<b>Subject:</b> <b>VARIOUS ELECTRICAL SYSTEM MALFUNCTION(S) RELATED TO C-15 CONNECTOR CORROSION</b>	<b>Bulletin No:</b> 09-005/14
	<b>Last Issued:</b> 03/14/2014

- This bulletin supersedes the previous bulletin 09-005/14, issued on 01/14/14 and 02/07/14 and 09-031/13, issued on 11/11/13. The REPAIR PROCEDURE has been revised.
- Changes are noted below in Red beside the change bar.

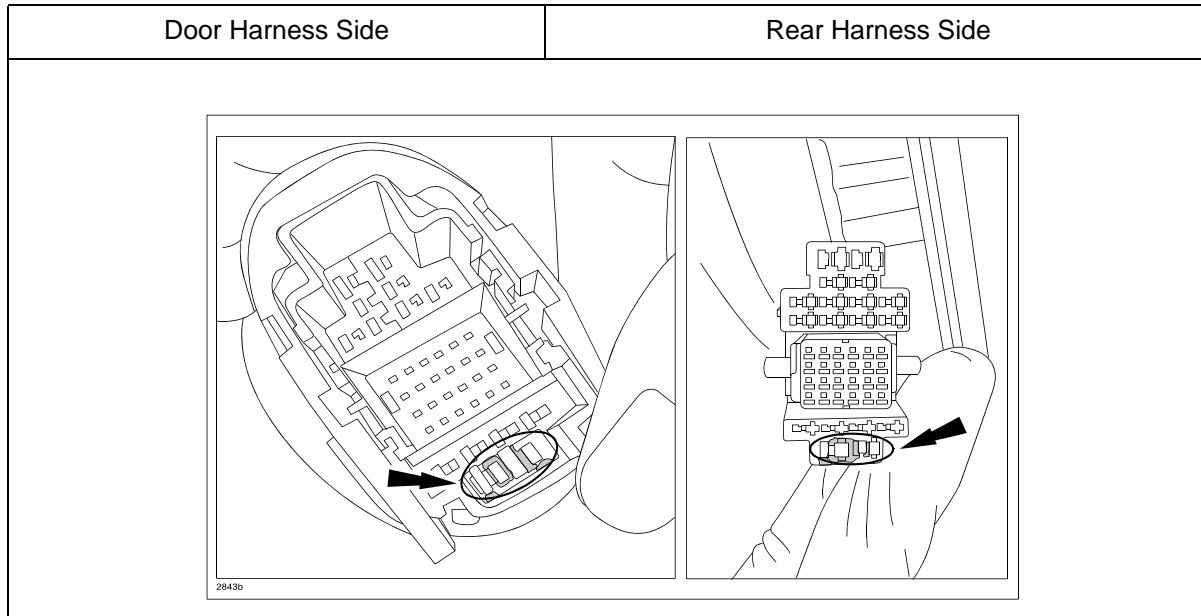
**MASS PRODUCTION CHANGES:**

- The front door harness grommet has been changed to improve sealing performance.
- Holes inside the front pillar (which are made for weight reduction), have been covered to prevent water intrusion.
